# HISTORIC AND DESIGN REVIEW COMMISSION July 05, 2017

HDRC CASE NO: 2017-314

**ADDRESS:** 2617 ROOSEVELT AVE

**TYPE OF WORK:** Exterior Modifications; Painting

# 2617 Roosevelt Avenue San Antonio, TX 78214 Travelers World RV Resort Front View

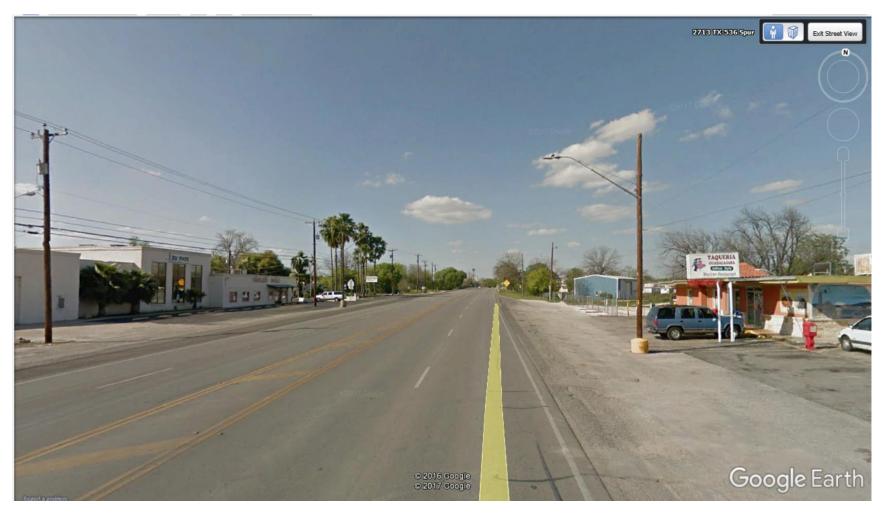
- b. STONE VENEER The applicant has proposed to clad the double height portion of the structure, located in the middle of the street facing façade with a faux stone veneer. The proposed cladding will be cream in color and will feature a rough cut stone profile. Per the Guidelines for Exterior Maintenance and Alterations 10.B.i. new features that alter or destroy the historic building character should not be introduced. While the existing structure lacks many historic architectural features, the proposed materials is not appropriate for the Mission Historic District and is not consistent with the Guidelines.

Staff does not recommend approval of items #4 through #6, the installation of the crème colored stone veneer, the installation of the modified entrance canopy and signage based on findings b,f and g.
